Re: Cotoni-Coast Dairies National Monument – Yellow Bank Access Evaluation, Santa Cruz County, California

Per your request, this is a preliminary traffic assessment of the schematic plan you prepared dated October 20, 2021, of the proposed Yellow Bank parking lot intersection with Highway 1 (Proposed Driveway Intersection) across from the Santa Cruz Regional Transportation Commission (SCCRTC) Panther Beach parking lot entry intersection with Highway 1. The schematic plan, which does not provide dimensions, is included herein as **Attachment 1**. The Yellow Bank parking lot is being considered by the Bureau of Land Management (BLM) and Trust for Public Land (TPL) as a new option to serve the Cotoni-Coast Dairies National Monument in northern Santa Cruz County, California. It will likely include a pedestrian /bicycle bridge over Highway 1 that will provide pedestrian and bicycle access to Panther Beach and the Monterey Bay Sanctuary Scenic Bike Trail (Scenic Trail).

Attachment 1
Highway 1 / Yellow Bank Trailhead Entrance
Intersection Channelization
Schematic Plan

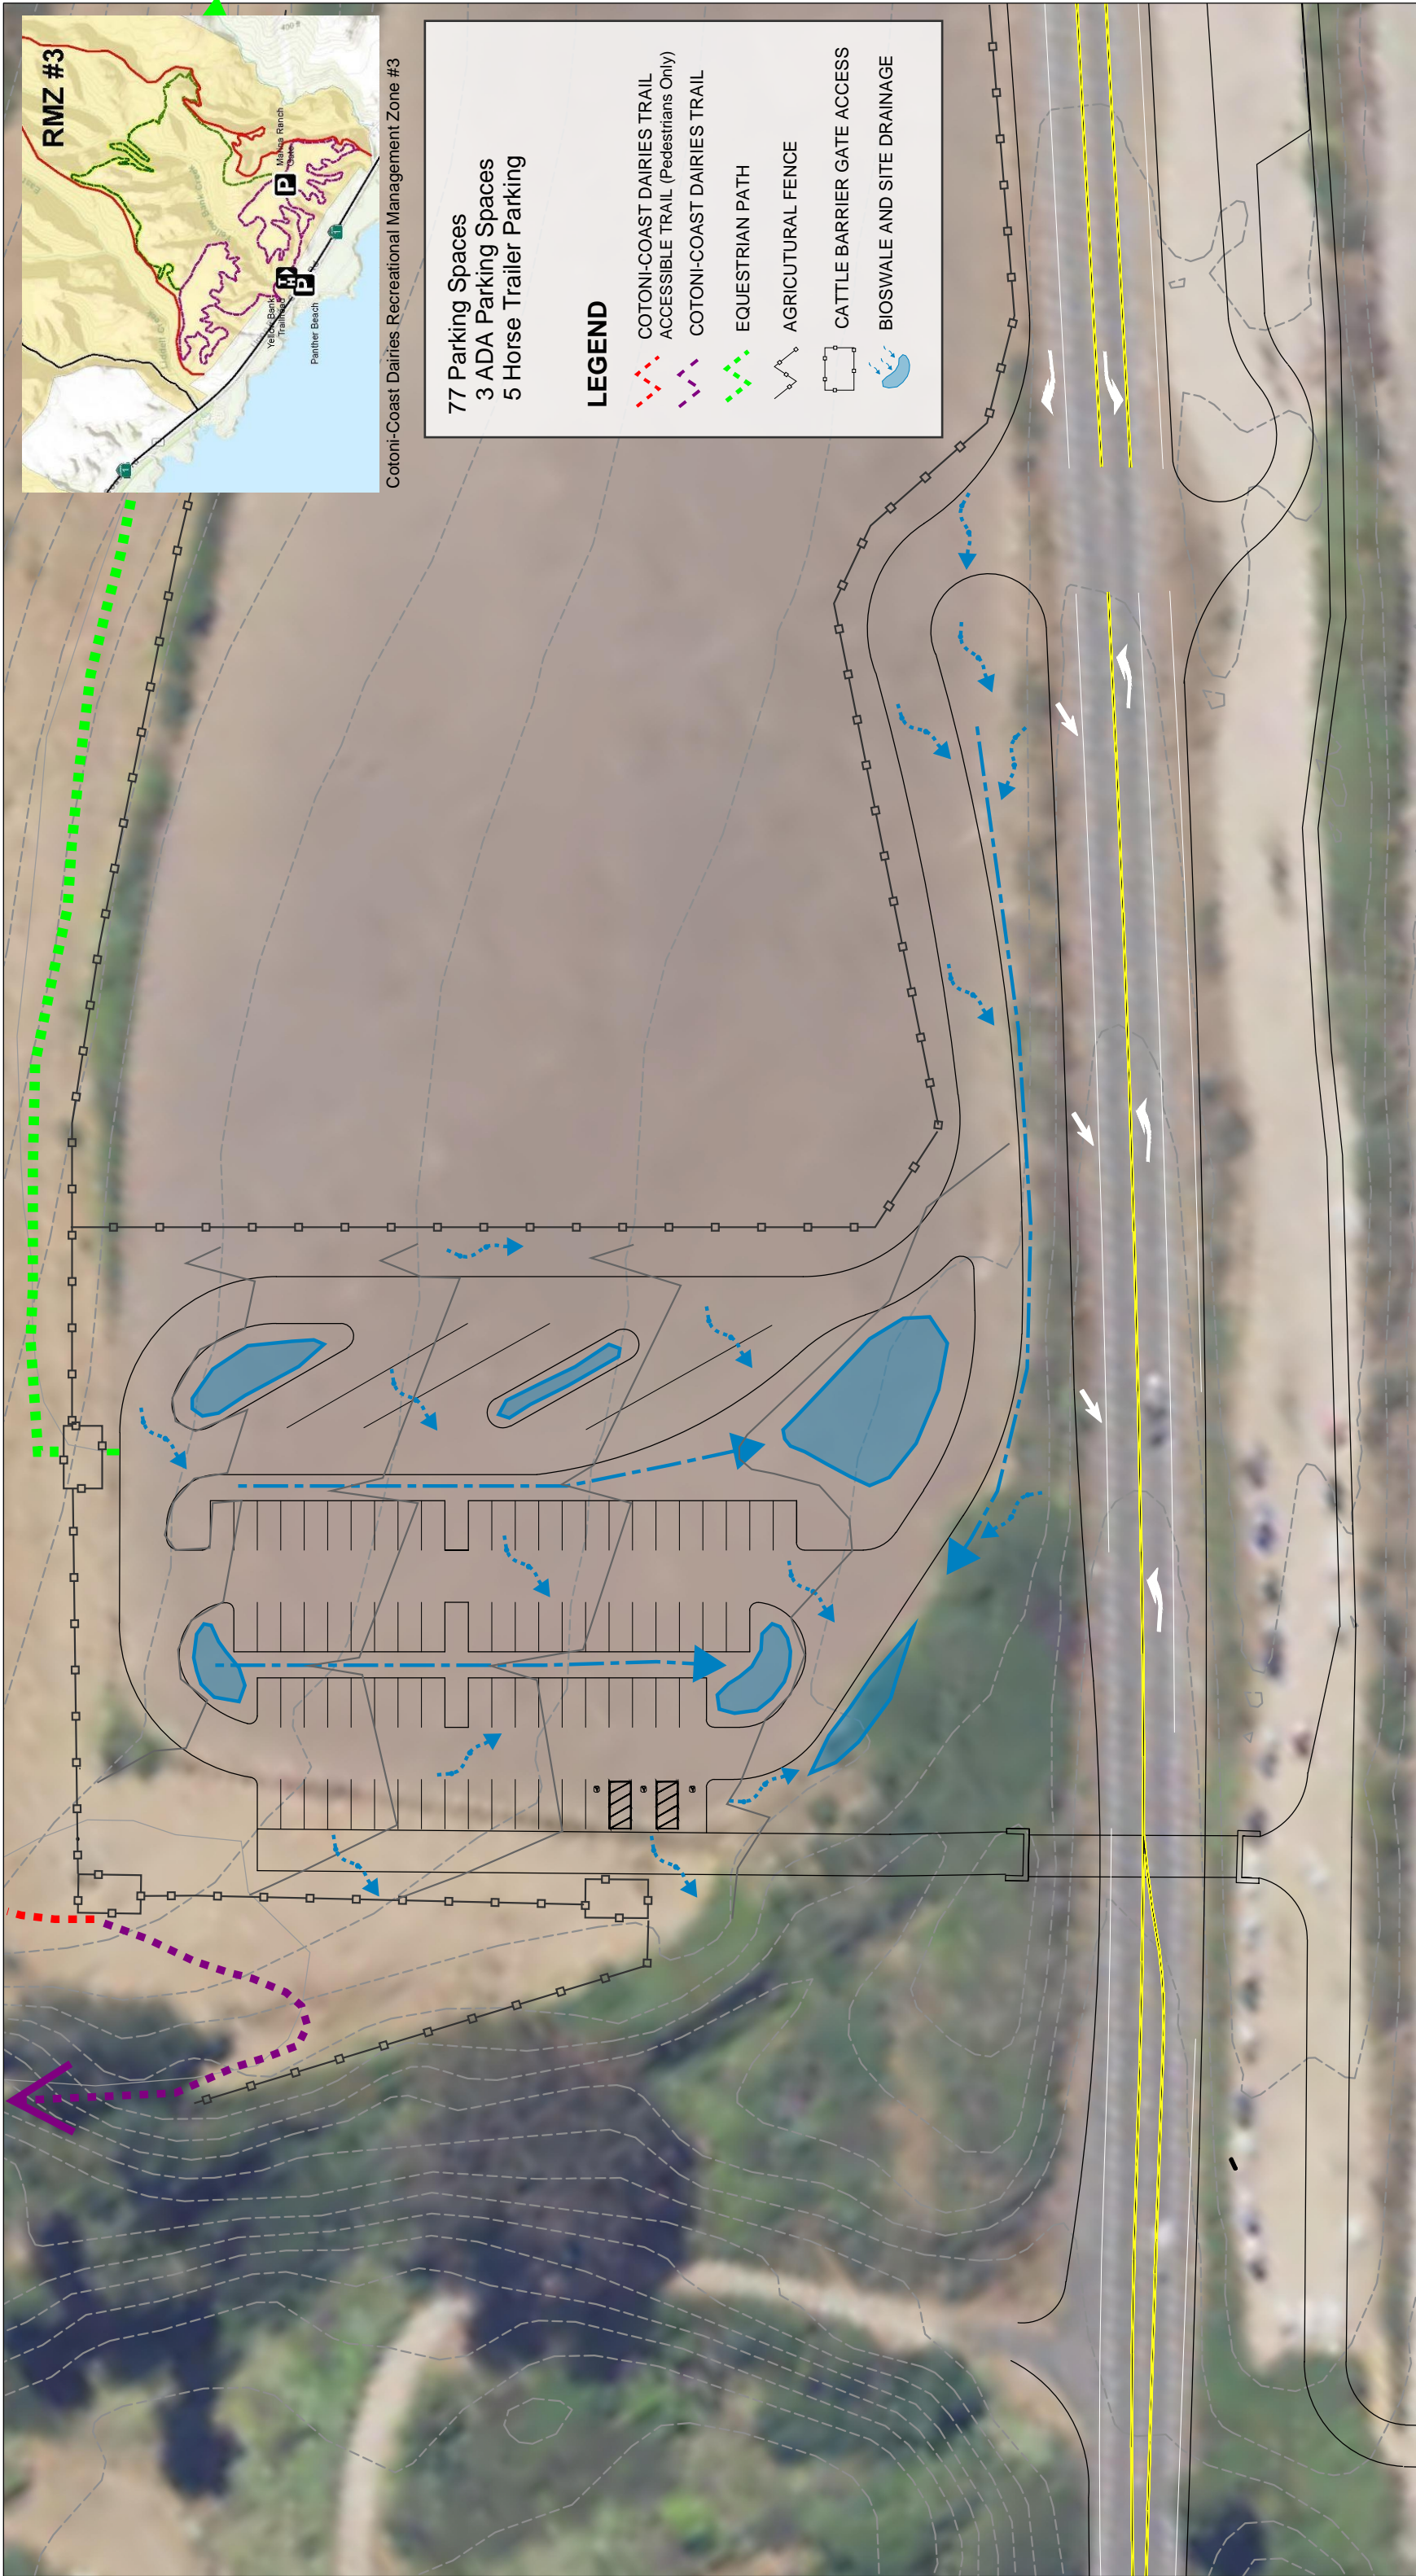
The proposed Yellow Bank parking lot driveway (Proposed Driveway) is proposed to be directly across Highway 1 from the proposed location of the entrance to the Panther Beach parking lot that will be constructed as a part of the Monterey Bay Sanctuary Scenic Bike Trail. This is also the approximate location of the driveways serving the existing unimproved Panther Beach parking lot. The Proposed Driveway would represent the fourth leg of the proposed intersection. To my knowledge, there is no formal restriction to driveway access at this location. The topography in the vicinity of the Proposed Driveway on the inland side of Highway 1 at this location is hilly but the slopes appear to be gradual enough to accommodate an entrance road to the parking lot such that acceptable horizontal and vertical entrance road alignments can be provided. The proposed driveway location should be acceptable to Caltrans subject to non-traffic considerations such as drainage, storm water quality, habitat conservation and endangered species, etc. The California Coastal Commission may have non-traffic issues as well.

- a. Sight distance looking south: The proposed driveway intersection location is near the north end of a crest vertical curve that limits sight distance to the south (left) for vehicles that would be exiting the proposed driveway location. A site visit was conducted on Sunday, August 28, 2021, to verify sight distance and field conditions in the Proposed Driveway vicinity. A total of 6 time gap readings were taken, with northbound vehicles approaching from the south visible for between 10.1 seconds and 13.1 seconds as they approached the approximate location of the Proposed Driveway. These exceed the requirement of 9.5 seconds per HDM Table 405.1A – "Corner Sight Distance Time Gap (Tg) for Unsignalized Intersections" to accommodate single unit trucks. This is greater than the typical requirement of 7.5 seconds to accommodate passenger cars but is the recommended criteria to provide for trucks with horse trailers, which would utilize this driveway. Adequate sight distance is provided to the south.

- b. Sight distance looking north: The Proposed Driveway is located about one-fourth mile south of Bonny Doon Road. There is a large radius horizontal curve between Bonny Doon Road and Proposed Driveway location. This does not appear to limit sight distance to the north to observe southbound traffic on Highway 1 approaching the Proposed Driveway Intersection. Adequate sight distance is provided to the north.

- c. The sight lines will be measured from a point 15 feet clear of the southbound travel way, which is the shoulder stripe. The embankment along the east side of Highway 1 in the vicinity of the Project Driveway will need to be designed to avoid encroaching into the sight line. This will need to consider future vegetation in the vicinity of the intersection.

- a. Left turn Deceleration Lane - No left turn channelization is currently provided at the existing Panther Beach parking lot driveway. A northbound left turn lane is proposed to be provided at the Panther Beach parking lot as a part of the Scenic Trail. A southbound left turn lane would be required as shown on Attachment 1. This will need to accommodate a minimum of two vehicles of storage, which would include one passenger car and one passenger car/pickup truck with a trailer. It will also need to accommodate deceleration. The posted speed limit is 55 miles per hour which indicates a design speed of about 60 miles per hour. Caltrans may allow 10 to 20 miles per hour of deceleration in the through lane, with about 40 to 50 miles per hour of deceleration in the left turn lane. Transitions from the existing centerline stripe to the left turn lane median width at the design speed of 60 miles per hour needs to be accommodated as well. The basic layout alternatives are indicated in HDM Chapter 400 – Figure 405.2A through C. These result in substantially different improvement lengths with varying construction costs and environmental effects. Some of the design criteria has likely been established during the design of the Panther Beach left turn lane. Caltrans should be consulted prior to proceeding into detailed channelization design. The California Coastal Commission may also have approval authority and is essential to be included early in the design process.

- b. Left Turn Acceleration Lane – A Left turn median acceleration lane (MAL) is apparently not being proposed for the Panther Beach left turn lane improvement. This component of the intersection would be similar to the MAL provided for eastbound left turns exiting the Wilder Ranch driveway. It does not appear that a MAL will be warranted based on level of service, which would be associated with unacceptable delay for left turns exiting the Proposed Driveway. This feature will need to be evaluated in consultation with Caltrans. It would add 12 feet more to the pavement width and much longer approach tapers with the associated impacts on habitat and construction costs.

- c. Right Turn Deceleration Lane – The northbound right turn volumes to enter the Proposed Driveway will be low and probably will not warrant full right turn deceleration lanes. If required, the deceleration lane would have a similar length to the left turn lane, although there would not be a vehicle storage requirement because right turns would be able to enter the Proposed Driveway without yielding to any conflicting traffic movement. At a minimum, a right turn deceleration flare will be required, conforming with HDM Figure 205.1, “Access Openings on Expressways.”

- d. Right Turn Acceleration Lane – A right turn lane is unlikely to be required due to the low volume delay anticipated of this movement. However, a right turn acceleration flare will be required conforming with HDM Figure 205.1, “Access Openings on Expressways.”

- e. Bike Lane - A bike lane may be required between the right turn lane and northbound travel lane. However, the shoulder width along Highway 1 is as narrow as 3 feet, which is not

adequate to provide a bike lane elsewhere along Highway 1. In addition, the Scenic Trail will provide a facility for bikes that would remove them from the high speed roadway in this area. This element of the design will need to be verified with Caltrans early in the design process.

- f. Entrance Road Alignment – The entrance horizontal alignment will need to accommodate cars and pickup trucks with horse trailers.

Based on the site visit, the entire Proposed Driveway Intersection channelization and sight distance provisions will be able to be physically accommodated at the proposed location. Caltrans will require much more detailed analysis of sight distance, traffic volumes, traffic operations, crash history as well as improvement plans showing horizontal and vertical alignment and supporting environmental, geotechnical, hydrology and other documents.
